**Report: ISSUE REPORT**  
**Function: Test, Adjust, & Balance**  
**Date: 02/08/2024**

**PROJECT**  
**02-05-24 PERRY'S - VERNON HILLS, IL**

**Speedtaps**  
**02/08/2024**

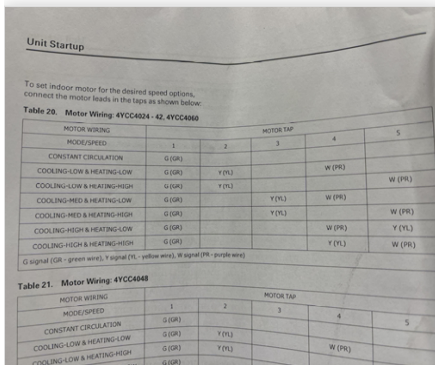
**Issue Name :** RTU-4: High on airflow  
**Description :** RTU-4 is multispeed unit scheduled for 600cfm with speed taps. Plans call for constant volume. Unit is within design at Speed tap 1, where G is landed. Manual indicates placing W(heat) at 4 and Y (cool) at tap 2, puts heating and cooling to low speed, this is 940cfm. Not possible to wire all stages to same speed. No indication if jumpers are allowed.

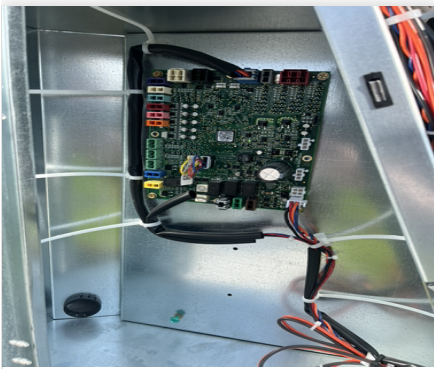
**Issue Name :** RTU-5: Not Operational  
**Description :** RTU-5 is not operational as the control board is fried. Waiting on replacement board. Unit not yet balanced as result.  
**Created By :** National TAB                      **Assigned To :** National TAB - Michael McDonnell  
**Status :** Open  
**Priority :**    **Asset Tag :**  
**Originated Date :** 02/08/2024 - Michael McDonnell - National TAB
